WALLARAH 2 COAL PROJECT

Response to Submissions: Amendment to Development Application SSD-4974

**WALLARAH 2 COAL PROJECT
AMENDMENT TO
DEVELOPMENT APPLICATION SSD-4974**

RESPONSE TO SUBMISSIONS

Access to Darkinjung Local Aboriginal
Land Council Properties

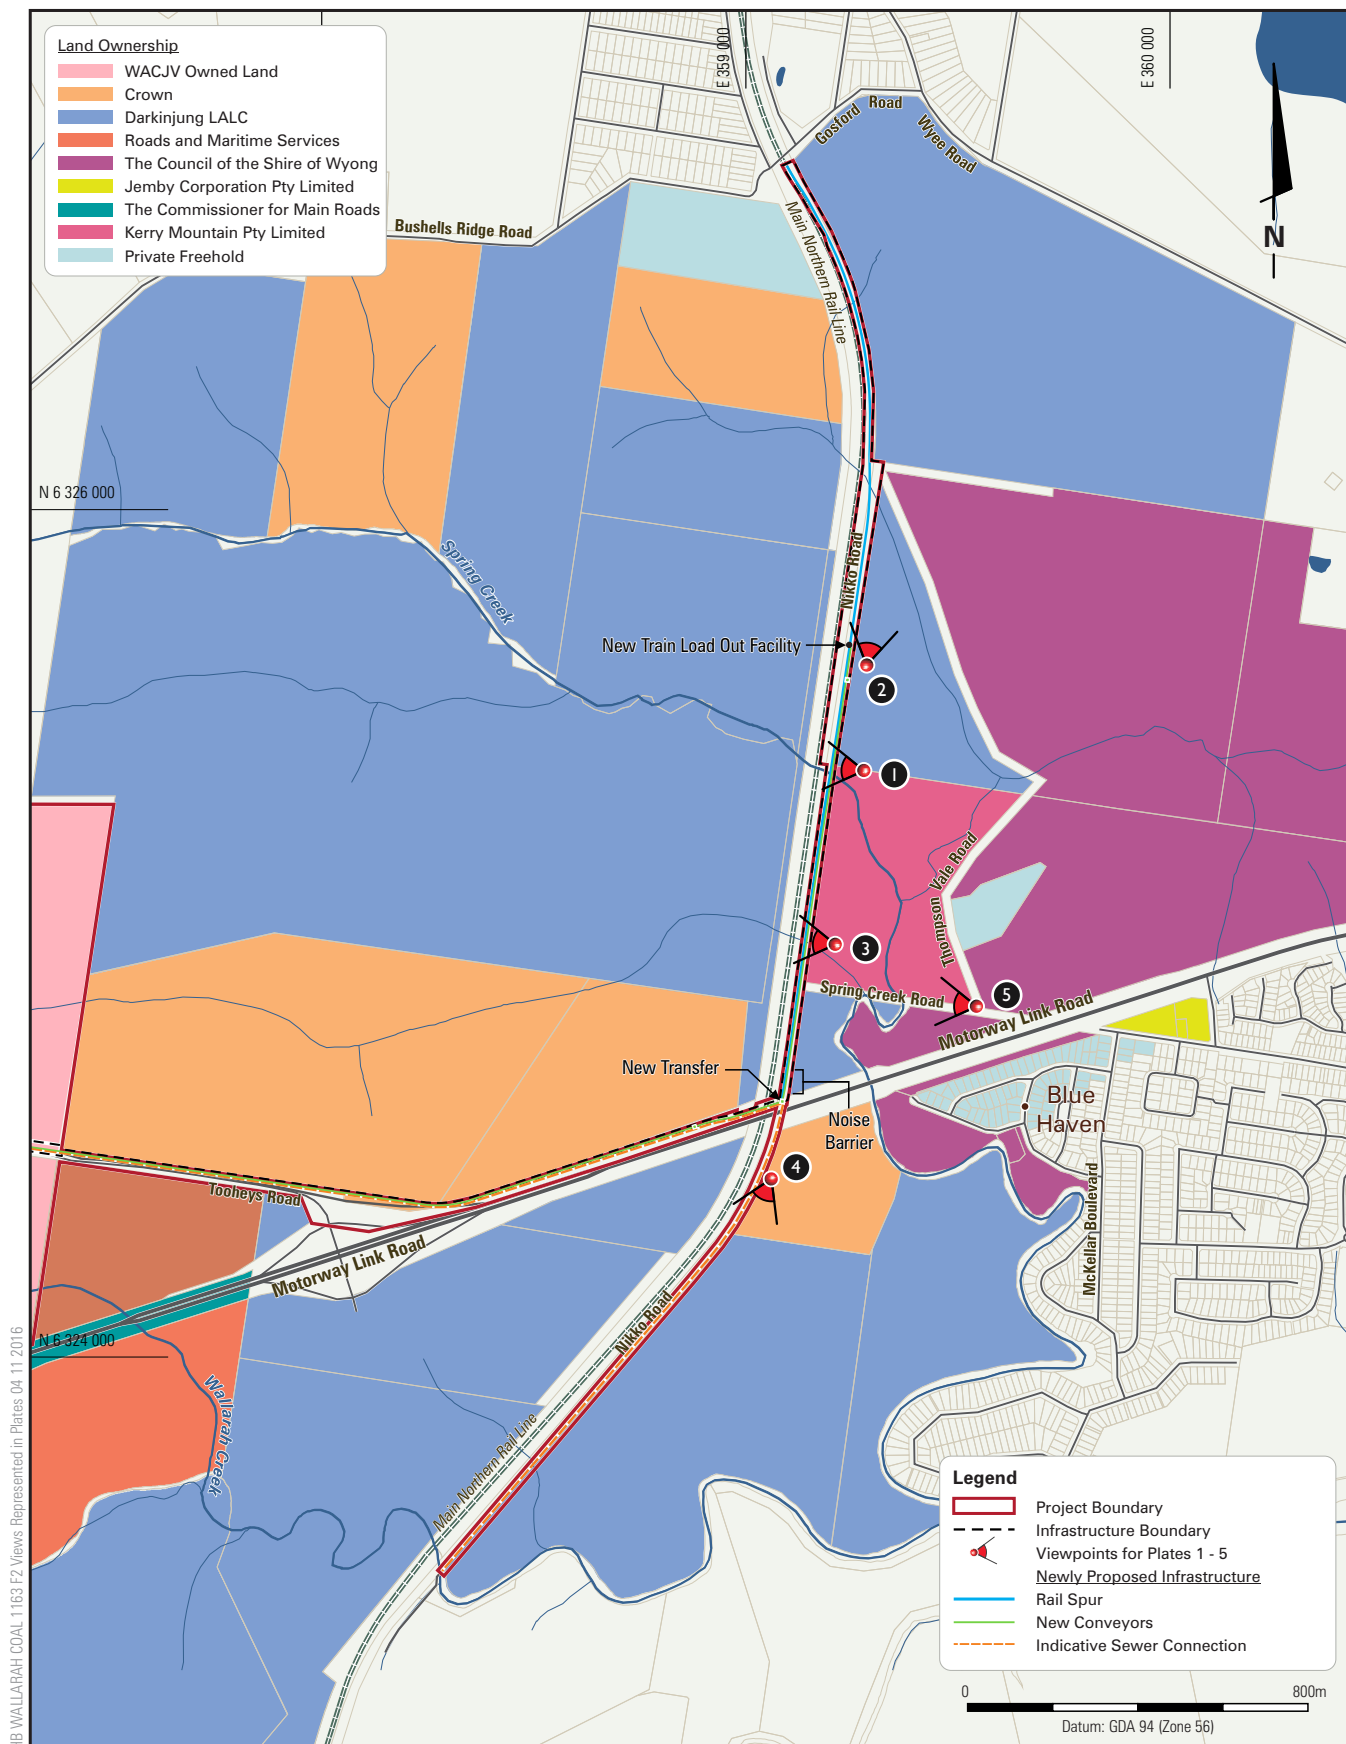
Whilst noting that some information has been provided on alternate access to land parcels in the event of closure of Nikko Road, the Department has reviewed numerous submissions which contend that access via other routes is not possible, practical or convenient. The Department requests further detailed information on all alternate access routes (including their standard and quality, and any potential limitations), design of the proposed shared road corridor and how access for emergency and telecommunications services would be managed and maintained for both the shared road corridor and for other land parcels.

DLALC owns several lots which abut Nikko Road to the north and south of the Motorway Link Road (see **Figure 3**).

Lot 204 DP 1117900 is adjacent to the Main Northern Rail Line and north of the Motorway Link Road. This lot is accessible from the south via Motorway Link Road and Thompson Vale Road. Thompson Vale Road consists of a short sealed section but is predominantly an unsealed, formed gravel road. Both the sealed and unsealed sections are required for access to Lot 204, DP 1117900 from the south. The primary access to lot is from the north via Wyee Road and Gosford Road. Both these roads are sealed main arterial roads, which Lot 204, DP 1117900 fronts onto. Both access points are shown on **Figure 3**. Wyee Road and Thompson Vale Road have better trafficability than Nikko Road. Nevertheless, the proposed access road beside the conveyor will ensure that Lot 204 DP 1117900 will remain accessible via Nikko Road.

Lot 16 DP 1210468 is adjacent to the Main Northern Rail Line and north of the Motorway Link Road. This lot is accessible via Thompson Vale Road and Spring Creek Road (see **Figure 3**). However, Spring Creek Road is an unformed road that is intersected by Spring Creek and is currently not accessible by vehicle for its full length (see **Plate 5**). Consequently, the preferred access to this lot is currently via Nikko Road. The proposed access road adjacent to the conveyor will ensure that safe, all-weather access to Lot 16 DP 1210468 via Nikko Road is maintained.

DLALC owns Lot 197 DP 1064536 located to the south of the Motorway Link Road. This lot is currently accessed via Nikko Road. The only infrastructure proposed to the south of the Motorway Link Road is a sewer connection (see **Figure 3**). The sewer connection will not impede access to Lot 197 DP 1064536.
